Groundwater Application Review Summary Form

Application # G- 181044

PUBLIC INTEREST REVIEW FOR GROUNDWATER APPLICATIONS

TO: Water Rights Section Date 4/25/2019
 FROM: Groundwater Section Travis Brown
 SUBJECT: Application G- 18644 Reviewer's Name Supersedes review of
 Date of Review(s)

Theis Drawdown Analysis – Low Yield Scenario

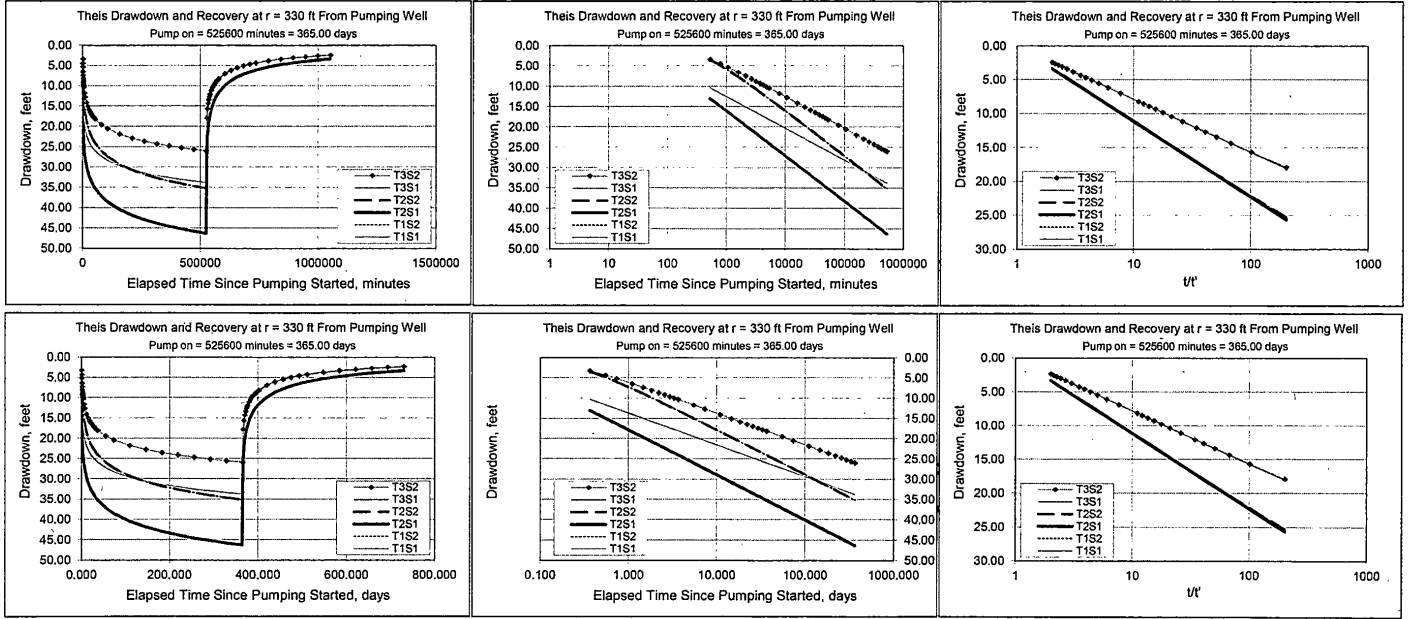
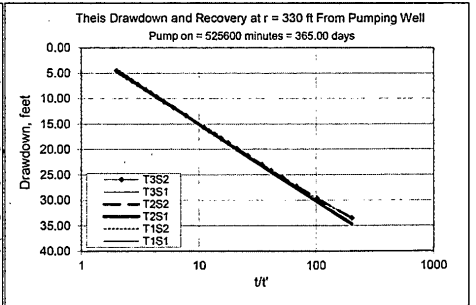
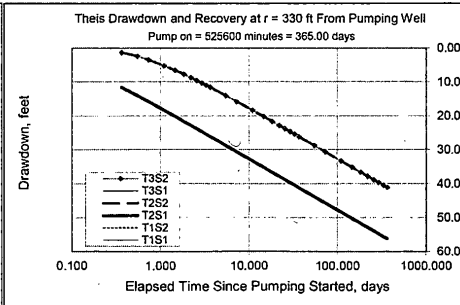
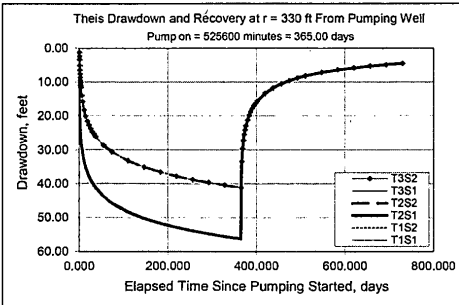
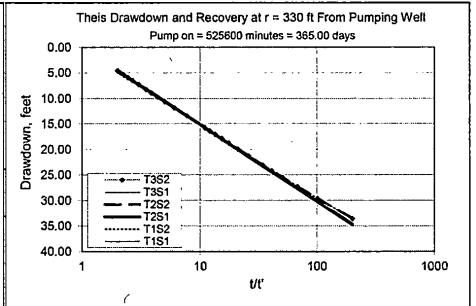
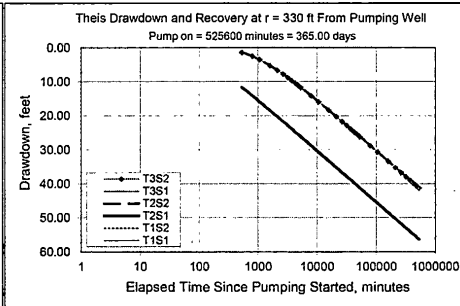
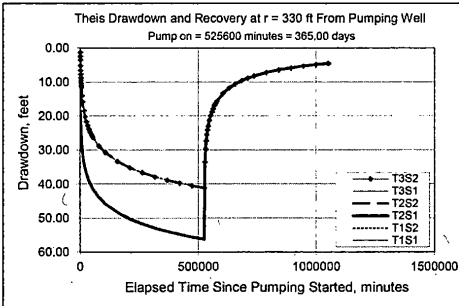
To assess potential interference with CLAC 15738 due to pumping of the proposed alluvial POA (1, 2, and 4), a drawdown analysis was conducted using the Theis (1935) method. Using aquifer hydraulic parameters from nearby pumping tests (CLAC 10930, 54178, and 56492) and regional studies (McFarland and Morgan, 1996), interference with CLAC 15738 is not anticipated to deprive Certificate 28042* of its customary use of groundwater (see Theis Drawdown analyses, attached).

Hunt (2003) transient stream depletion model

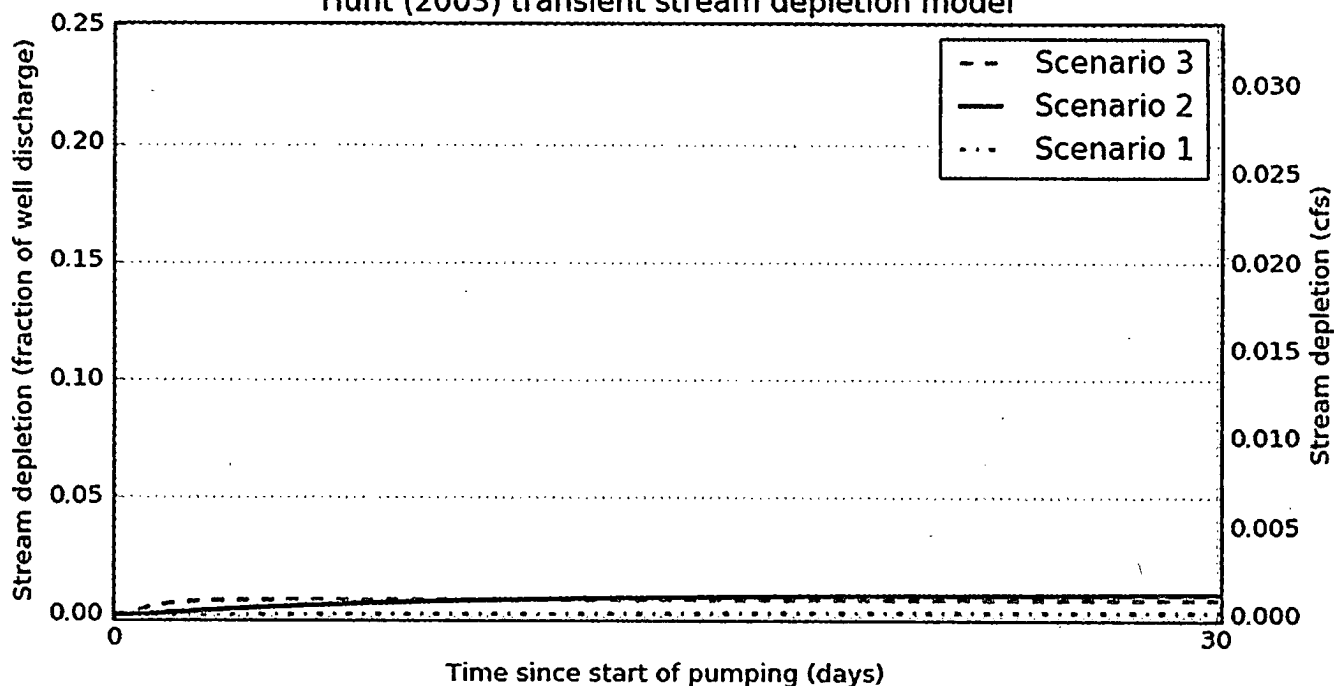
Comments: C3a: Potential depletion of (interference with) SW 1 (Eagle Creek) and SW 2 (Currin Creek) was estimated using the Hunt 2003 model. Hydraulic parameters used for the model were derived from regional data or studies of the hydrogeologic regime (Pumping Test Reports; OWRD Well Log Query Report; Conlon et al., 2003, 2005; Iverson, 2002; McFarland and Morgan, 1996; Woodward et al, 1998) or are within a typical range of values for the parameter within the hydrogeologic regime (Freeze and Cherry, 1979; Domenico and Mifflin, 1965). See attached "Stream Depletion Analysis" for the specific parameters used in the analysis. The Hunt 2003 model was only quantitatively evaluated for POA 6 and SW 1, because the only parameter anticipated to change between the various other alluvial POA and SWs is the distance between the POA and SW; since the

distance from well to stream for all other POA-SW combinations is greater than the distance between POA 6 and SW 1 (1,515 ft), the POA-SW interference for all other combinations should be less than that for POA 6 and SW 1.

The Hunt 2003 analytical model results indicate that depletion of (interference with) SW 1 due to pumping of POA 6 is anticipated to be much less than 25 percent of the well discharge at 30 days of continuous pumping. The depletion of (interference with) SW 1 and SW 2 due to pumping of the other alluvial POA is likewise anticipated to be much less than 25 percent of the well discharge at 30 days of continuous pumping. This is most likely due to the substantial thickness of fine-grained sediments underlying SW 1 and SW 2.
